## Evaluation of proposed move for Water Right Nos. 41296 and 43075

Proposed: Move water right nos. 41296 and 43075 to a new well location, 127 ft to the northeast of 41296 and 2,513 ft to the southwest of 43075.

Data Set: C:\Users\trevora\Documents\2022\_moves\43075\43075 Current.aqt

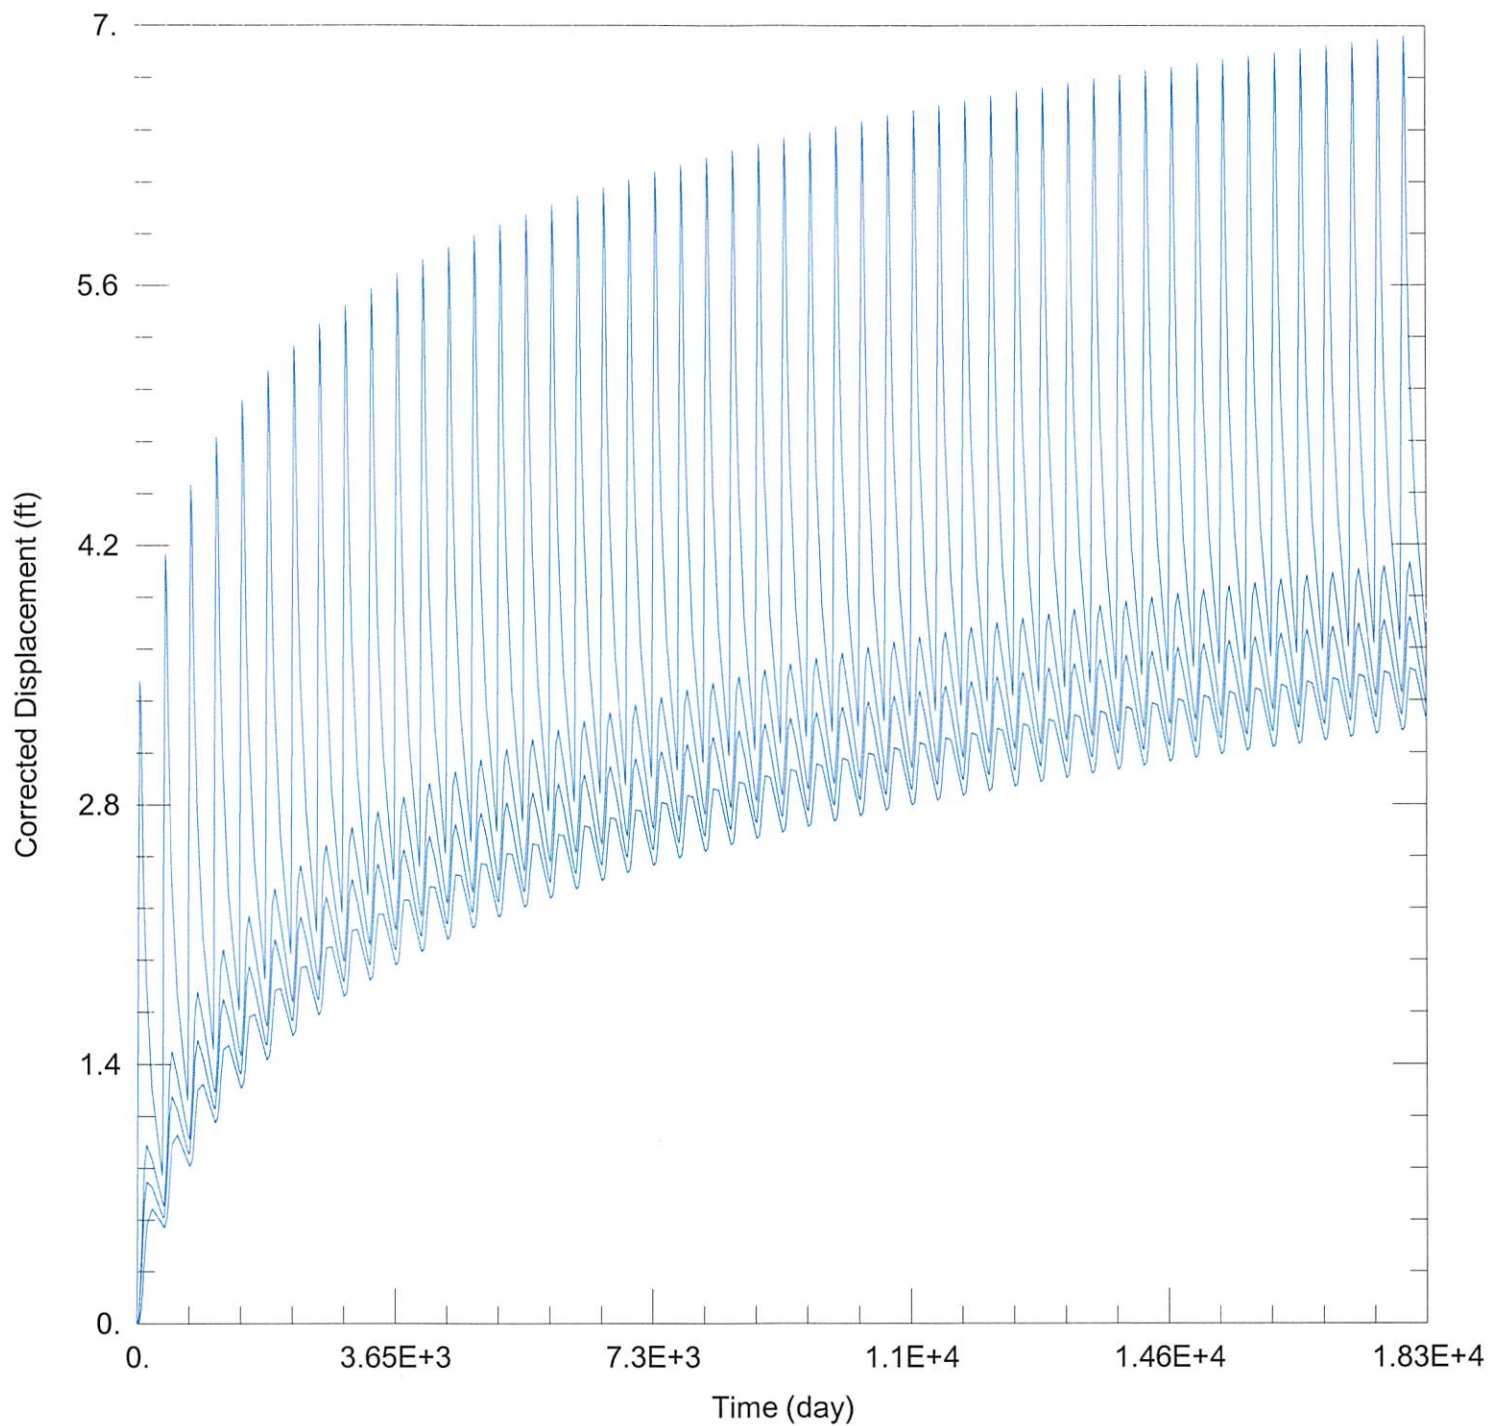
42943: Drawdown from current location = 4.10 ft

40543 & 41603: Drawdown from current location = 3.81 ft  
Drawdown from proposed location = 8.10 ft  
Net drawdown = 4.3 ft

Net drawdown exceeds the drawdown allowance of 4.0 ft for water right nos. 40543 & 41603. Critical well analysis is necessary on that well.

Total drawdown of 80.3 ft is less than the EDC and PDC, so this well is **not critical**.

Data Set: C:\Users\trevora\Documents\2022\_moves\43075\43075 Proposed.aqt

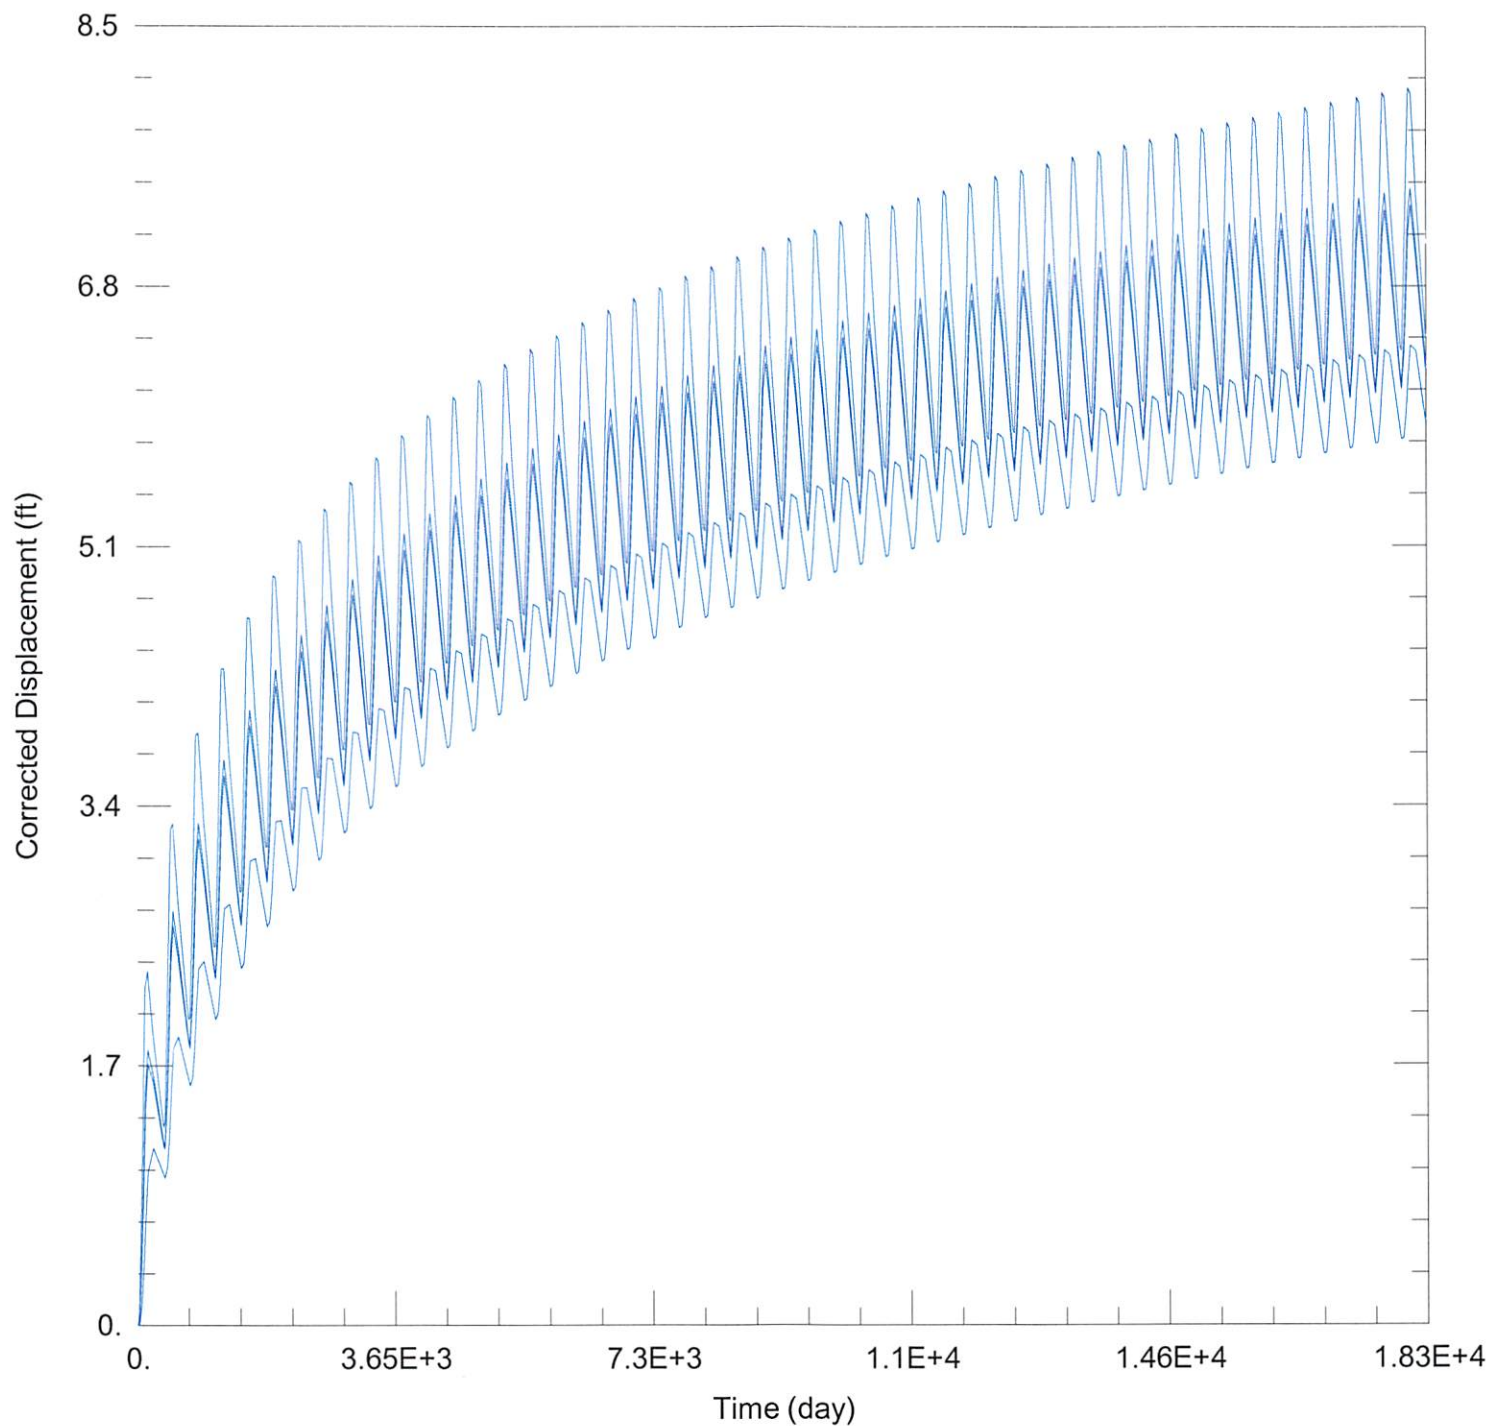
Drawdown from proposed location = 7.33 ft
